Approved Section 4.55 (2) Modification Application

No: SSD 6966 MOD 1 Granted on 19 August 2021

ONE SYDNEY HARBOUR

BARANGAROO

2 Lobby Facade Detail - Elevation
1 : 25

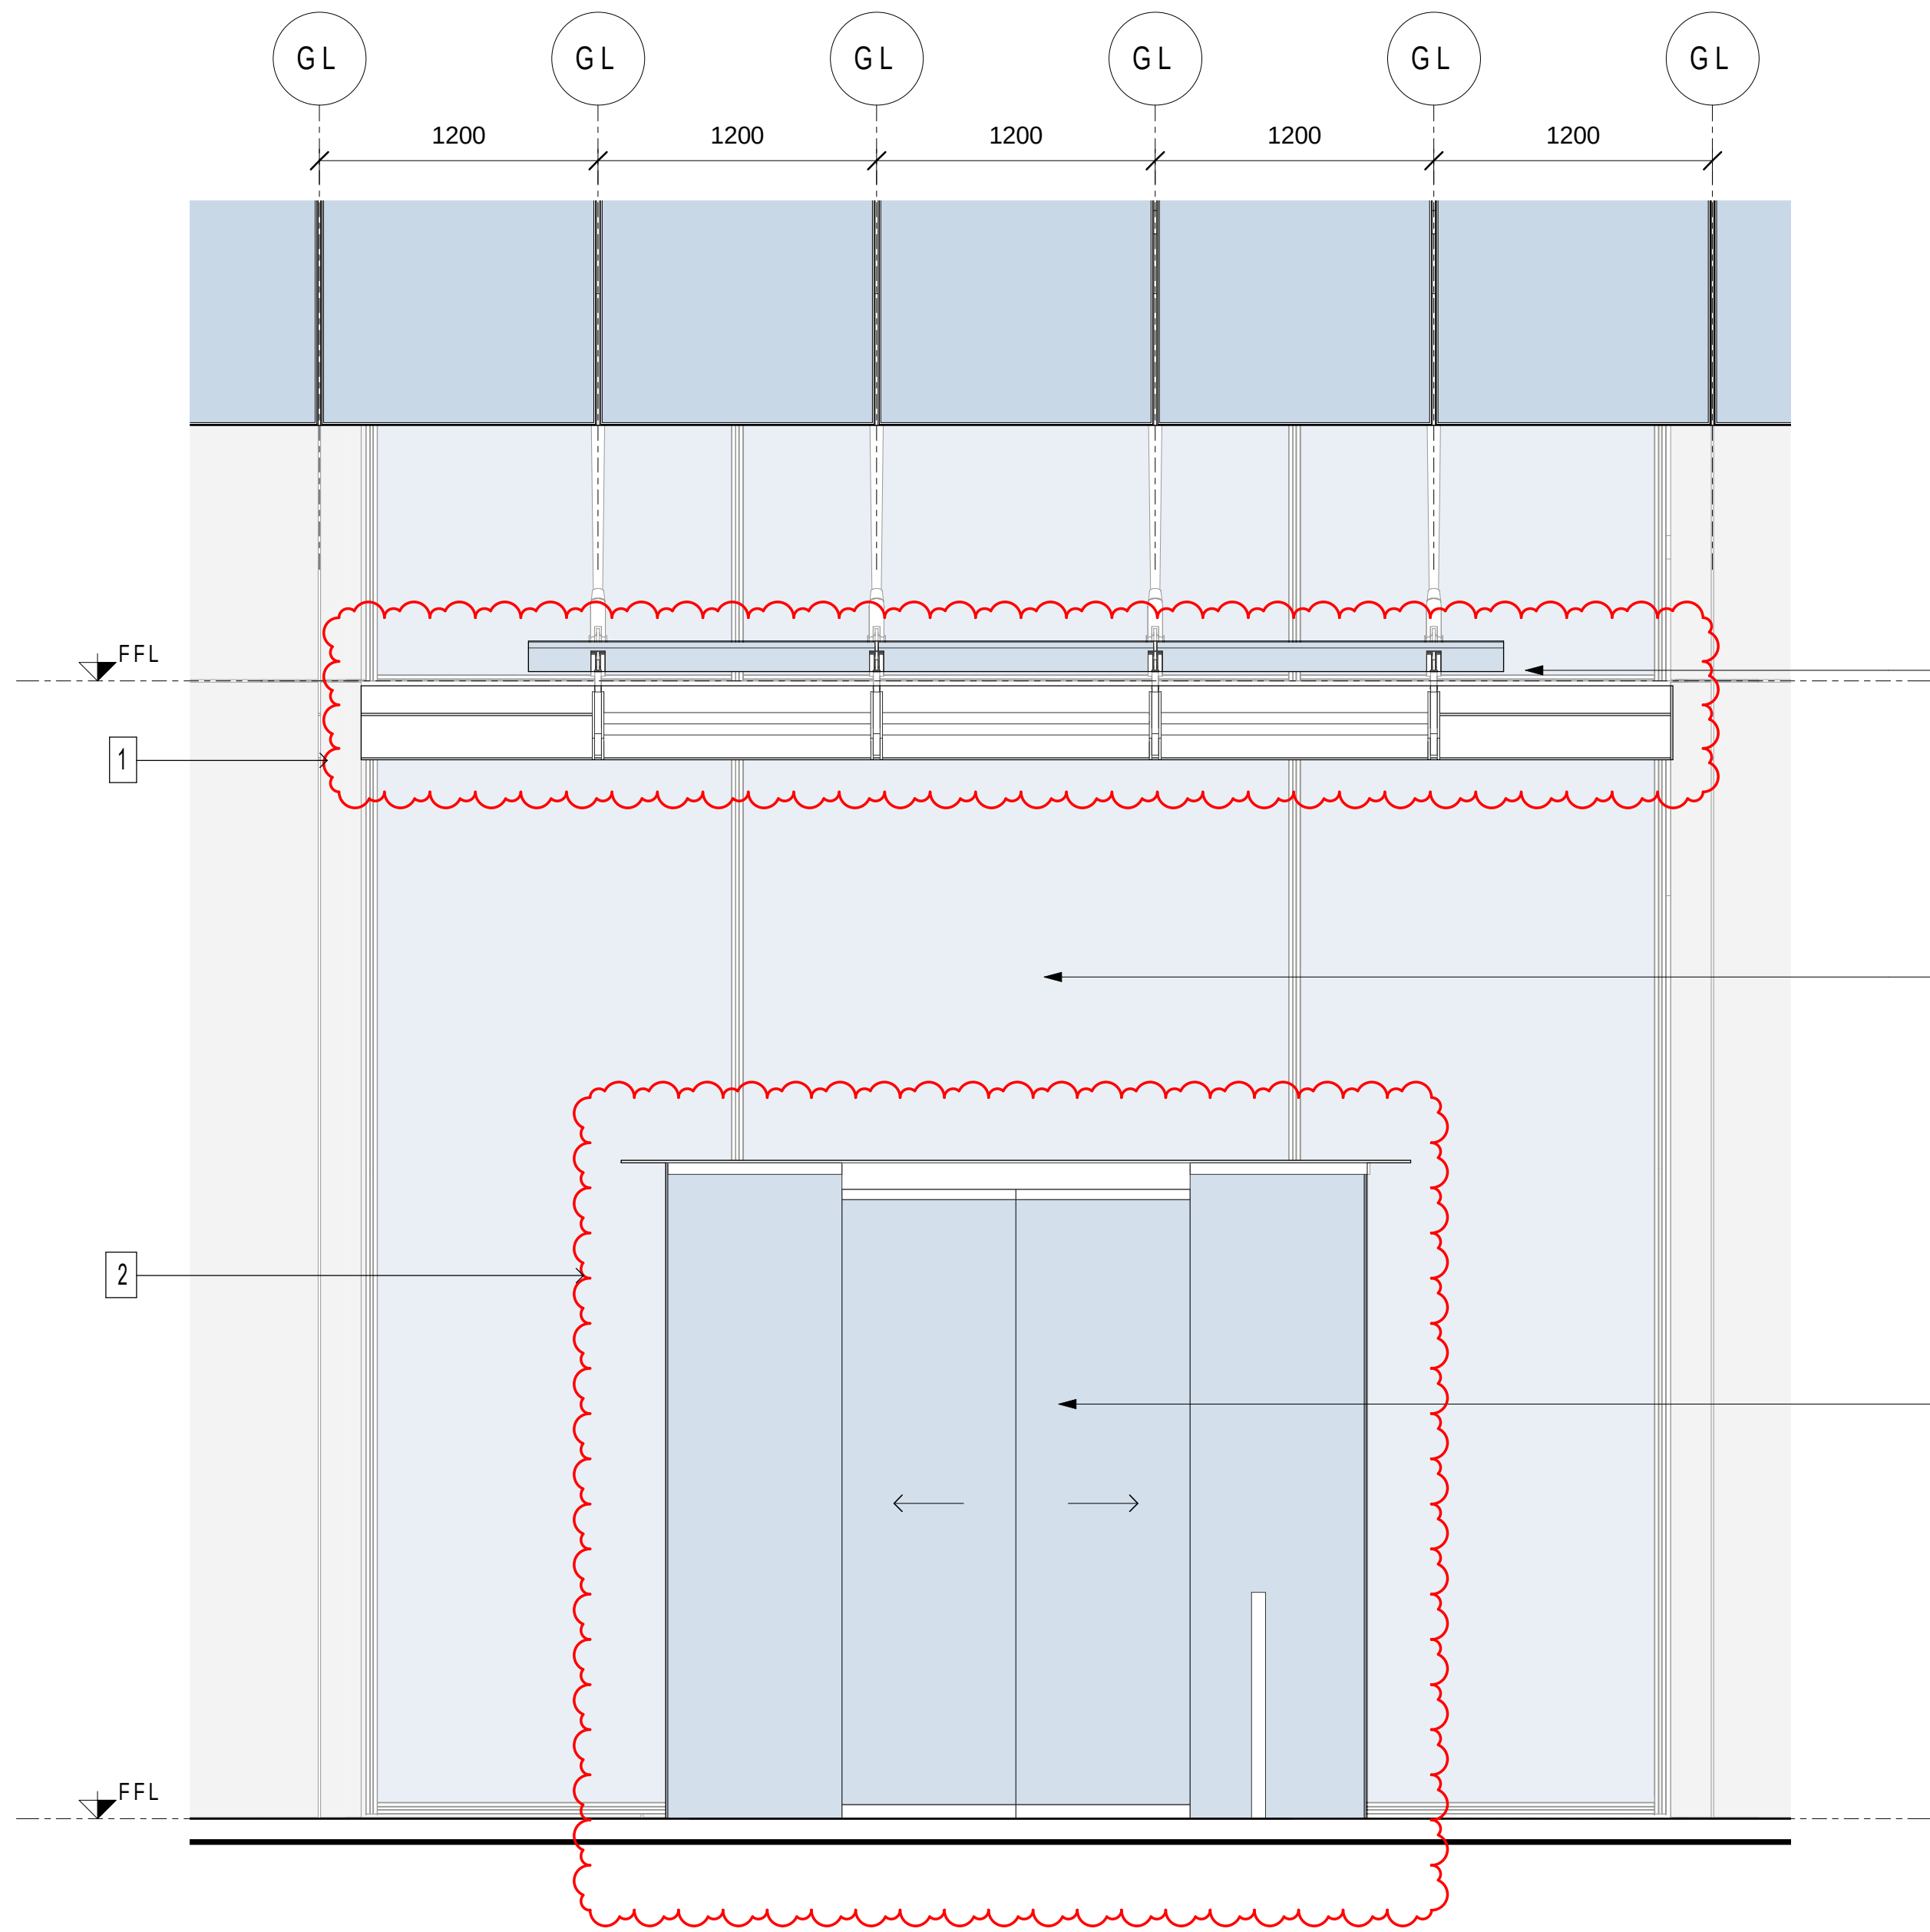
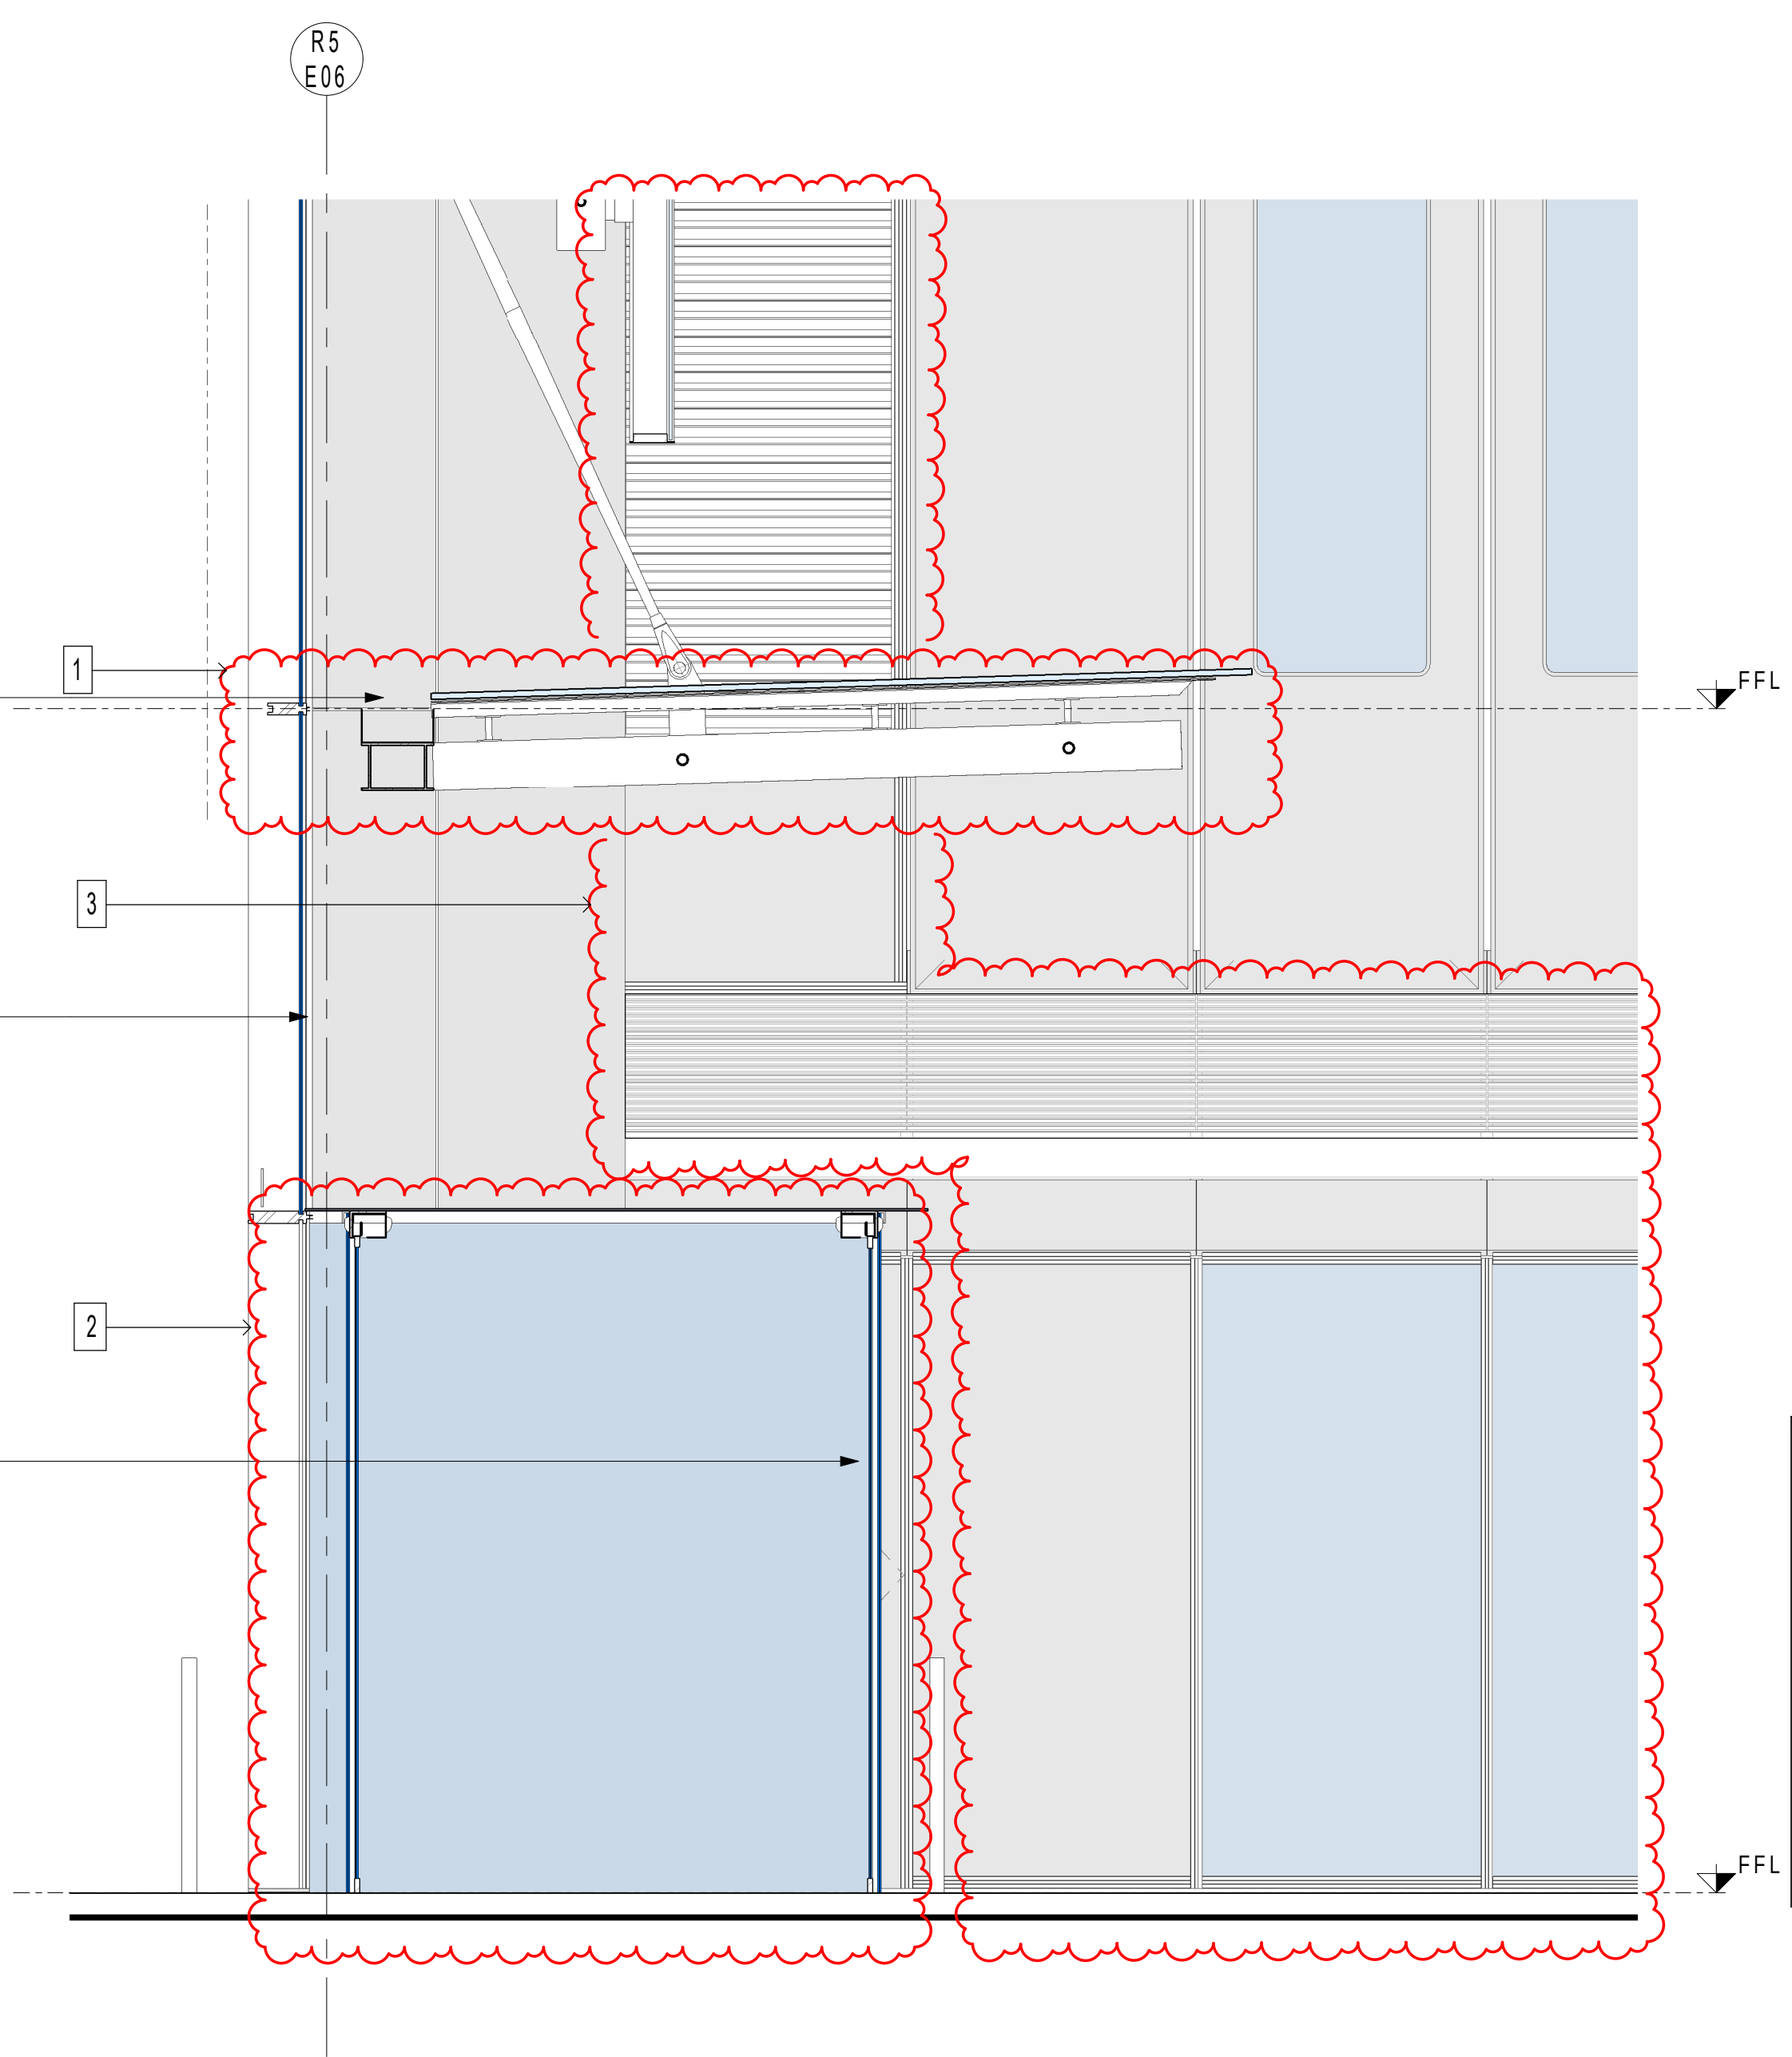
- MODIFICATION:
1. UPDATED AWNING DETAILS
 2. UPDATED ENTRY VESTIBULE, POSITION AND DETAILS
 3. UPDATED TYPICAL RETAIL FACADE
